PCO #003

Project: 21-501 - Collin County Adult Detention Facility, Phase 1 Addition
 4300 Community Avenue
 McKinney, Texas 75071

Prime Contract Potential Change Order #003: PR # 1 - Civil, Structural, Arch Changes

Provide for additional work required to complete all work associated in PR # 1 dated February 17, 2022.

EROSION CONTROL PLAN
COLLIN COUNTY ADF - PHASE 1 ADDITION
COLLIN COUNTY JUSTICE CENTER
4300 COMMUNITY AVENUE
CITY OF MCKINNEY, COLLIN COUNTY, TEXAS

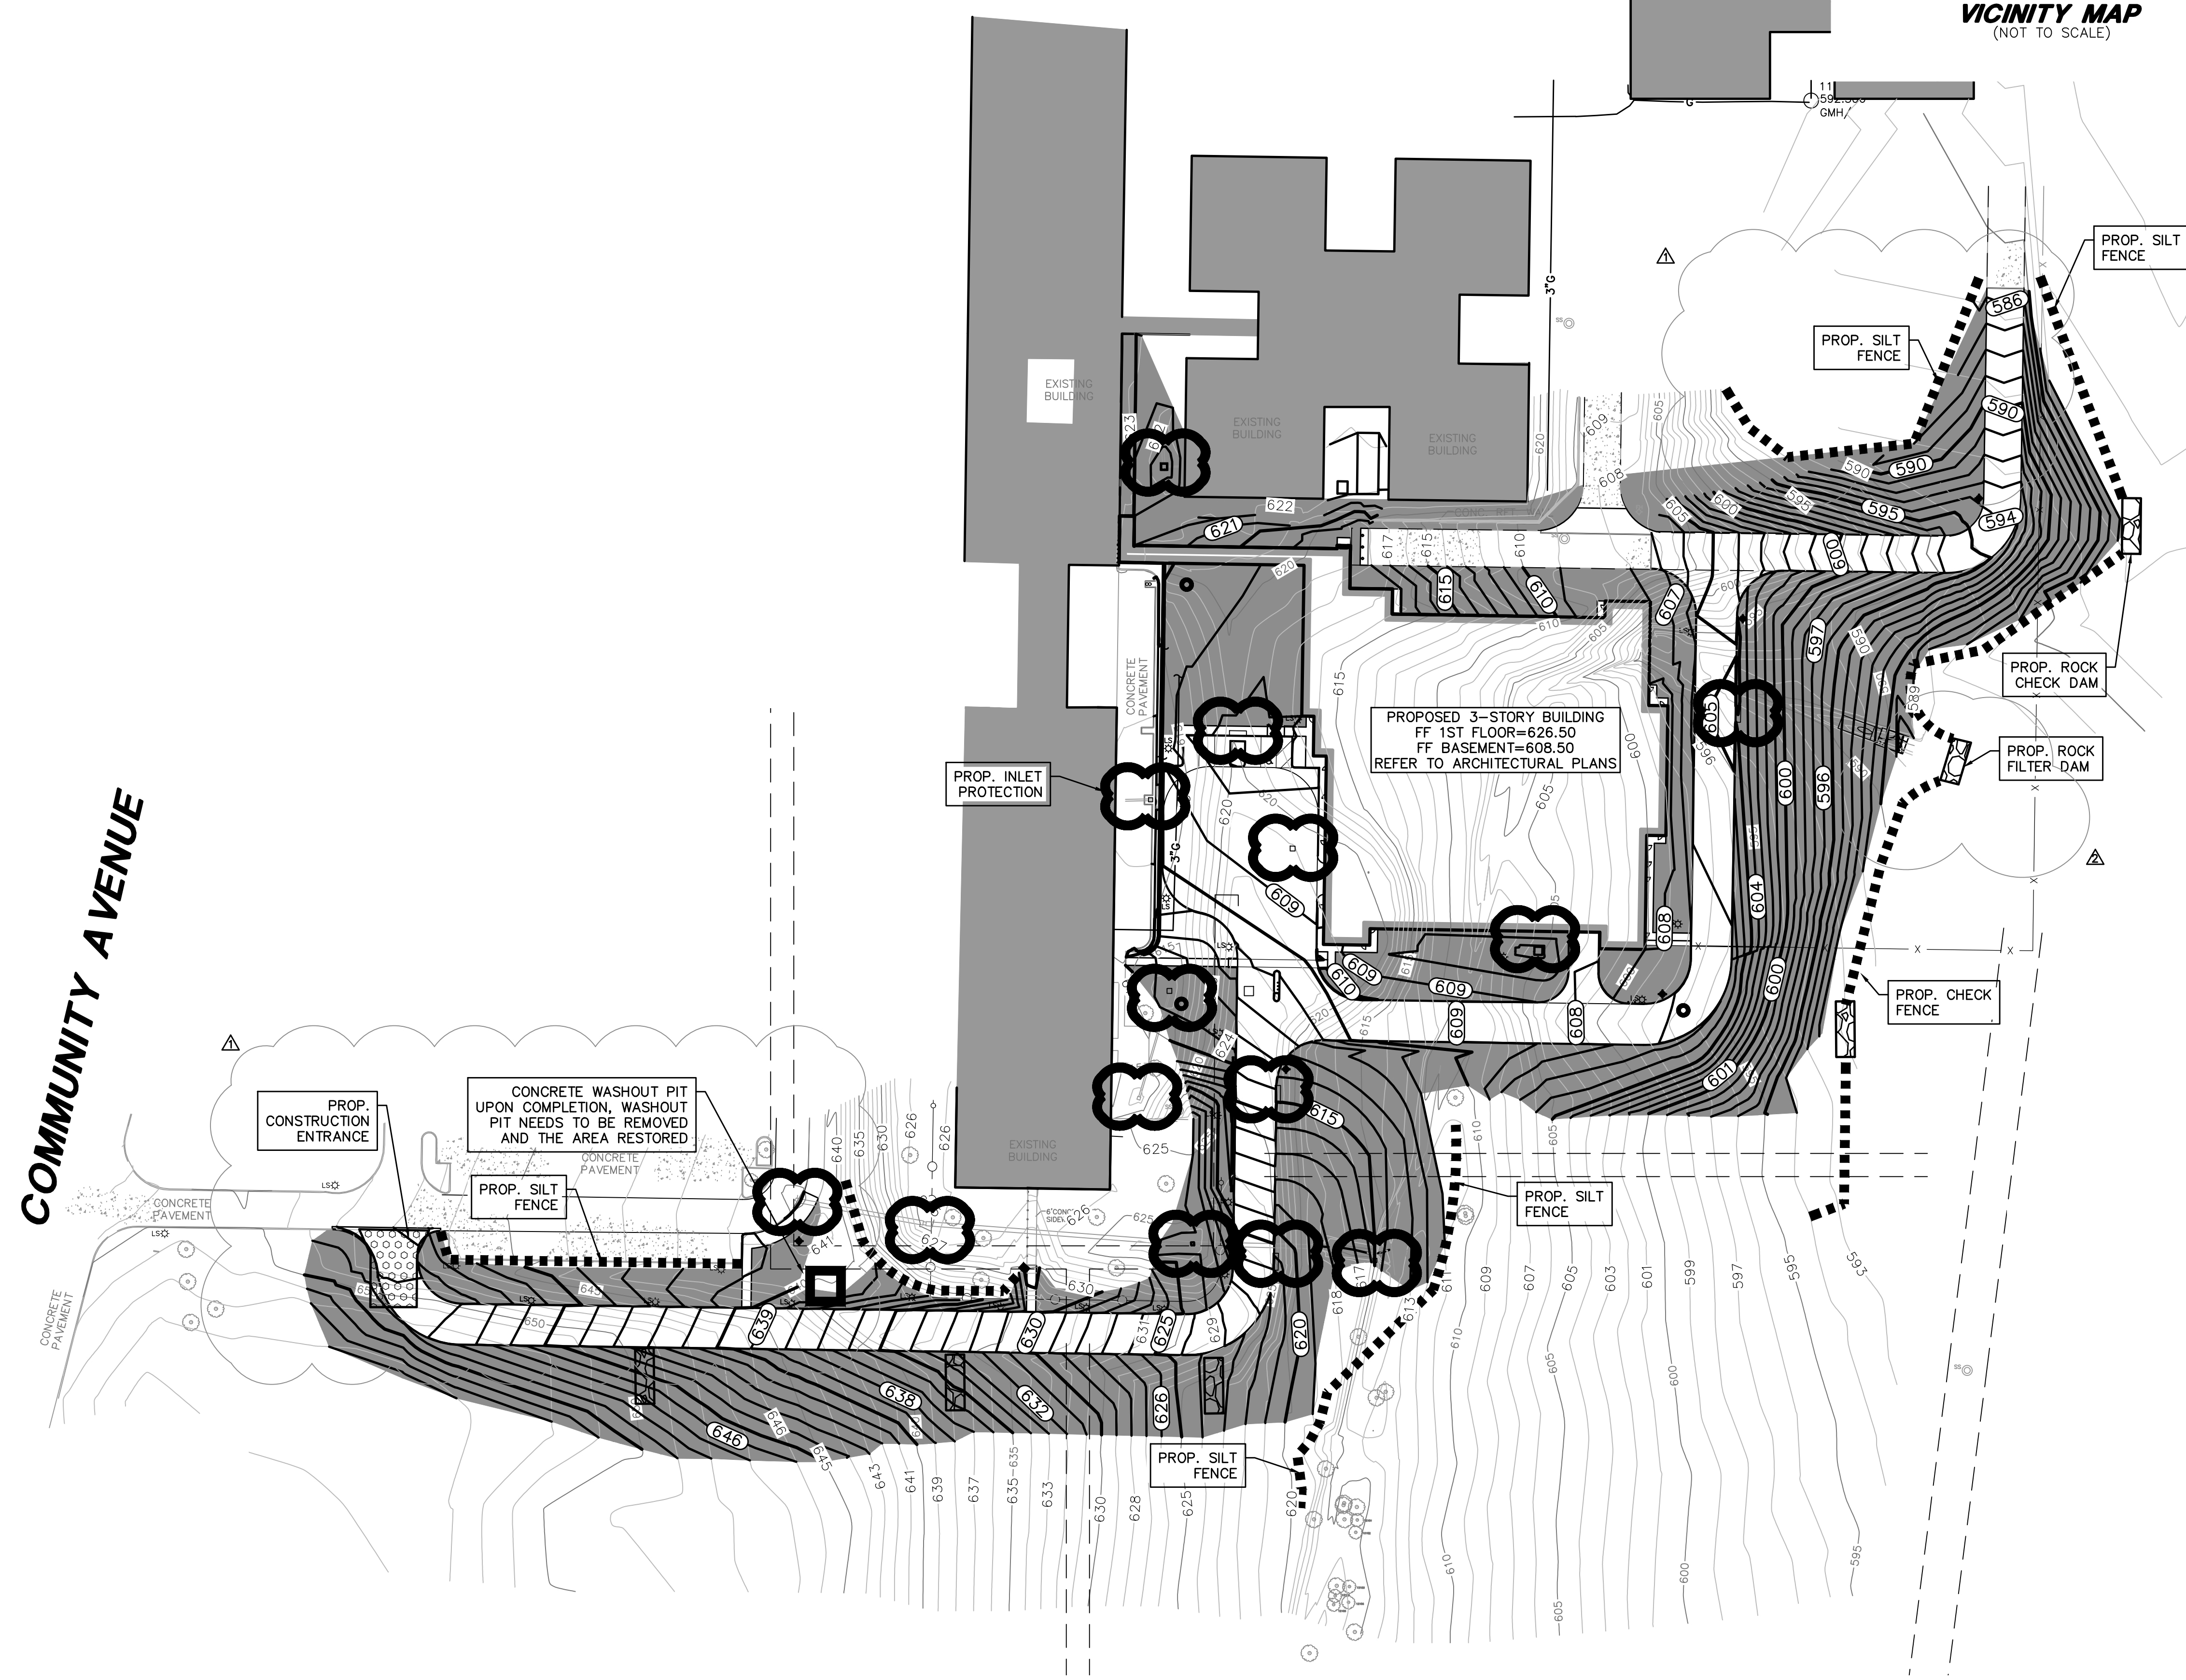
Pricing for additional work required to provide an additional ⁴²⁰200' of silt fence and relocate 500' of silt fence as shown on PR#1.

DOOR SCHEDULE, DOOR TYPES, & FRAME ELEVATIONS

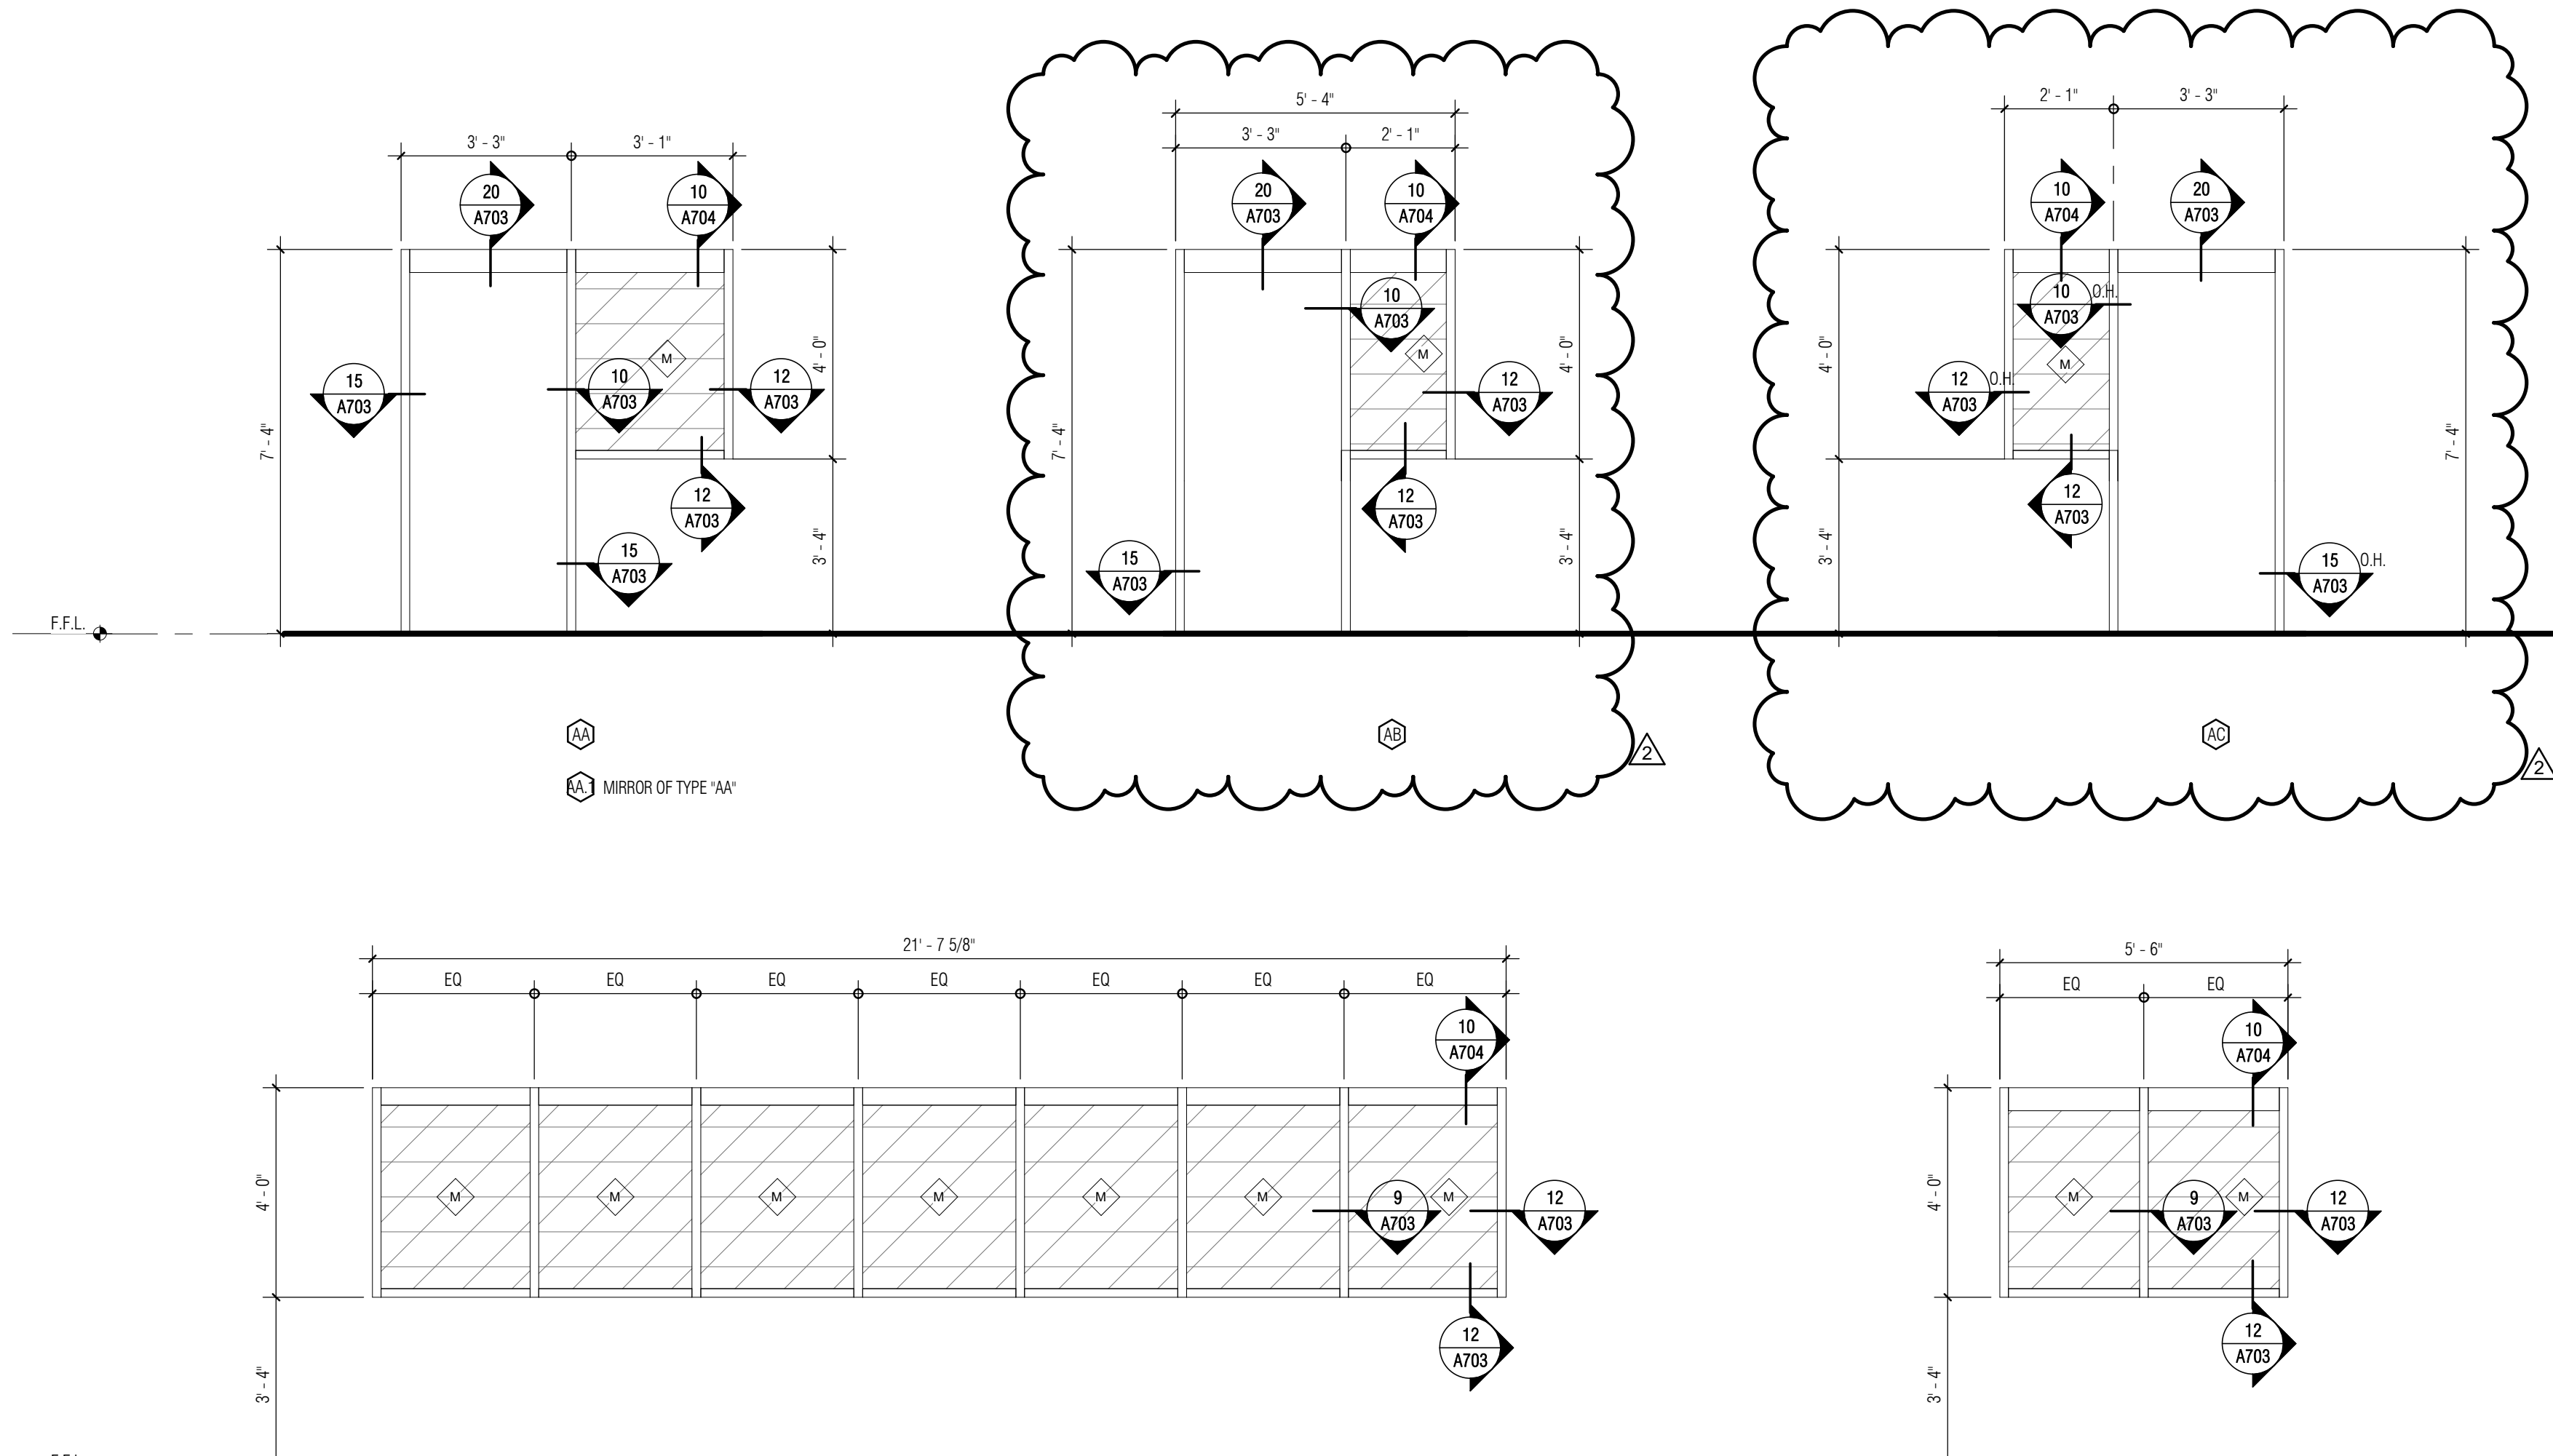
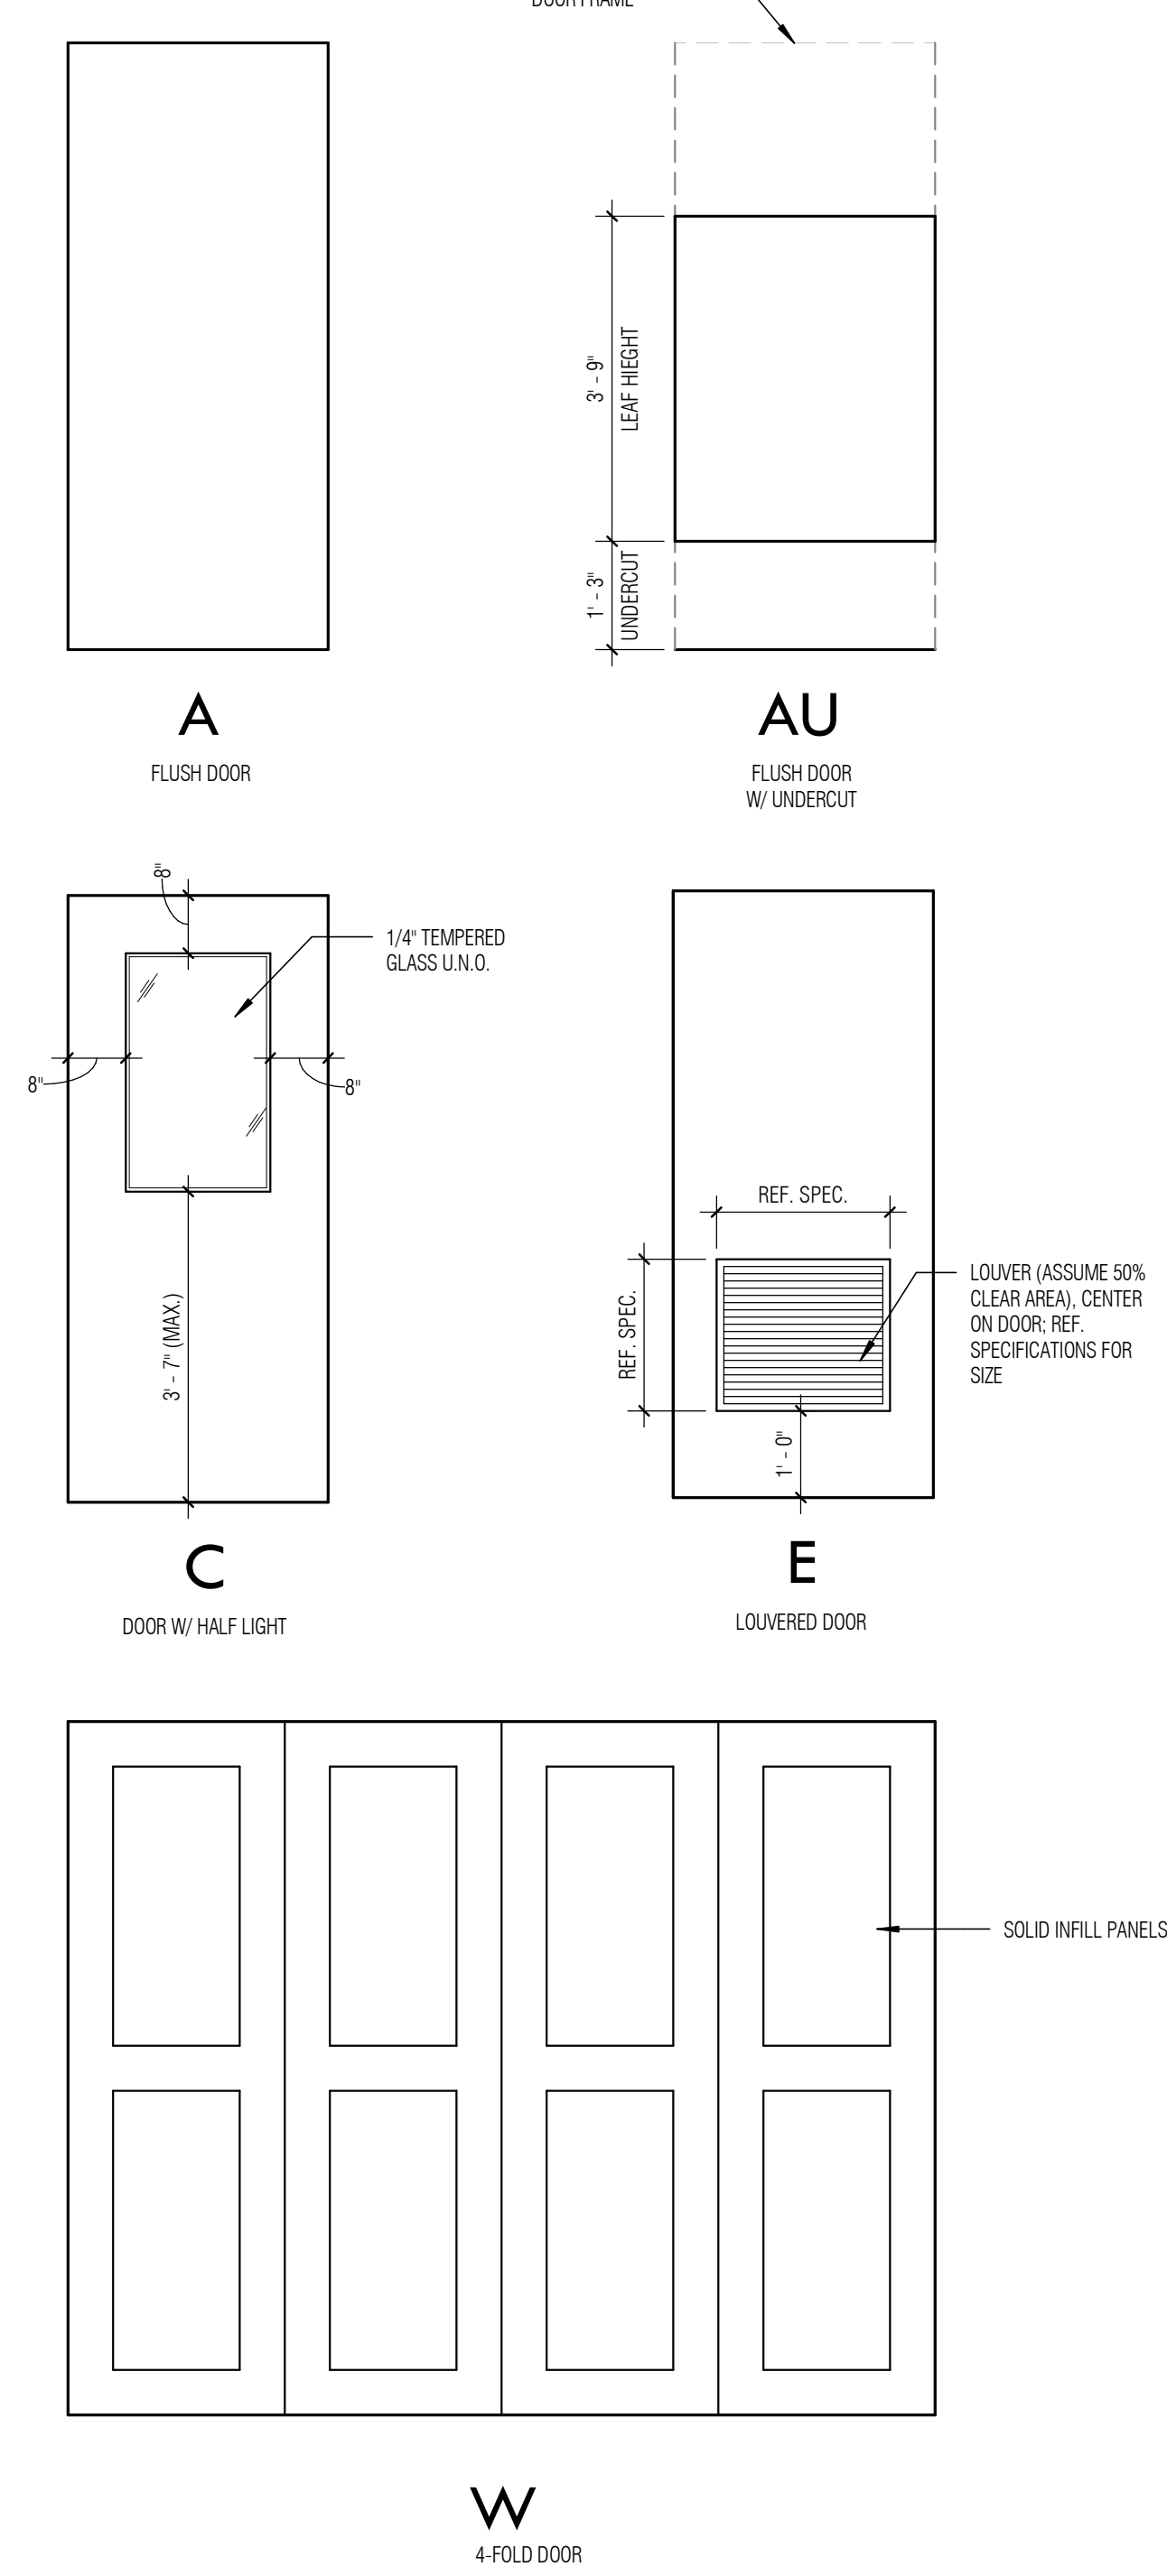
- Item No. 3. Per submittal review of precast walls, pier locating dimensions, top of pier, and grade beam dimensions were modified
- Item No. 4. Revise the size of door frames 'AA' and 'AC' frames to course with masonry. Doors 1136, 1139, and 1140: Change door sizes from 7'-2" to 7'-0" so the 4" heads course with the masonry. Refer to Arch drawings for these changes.
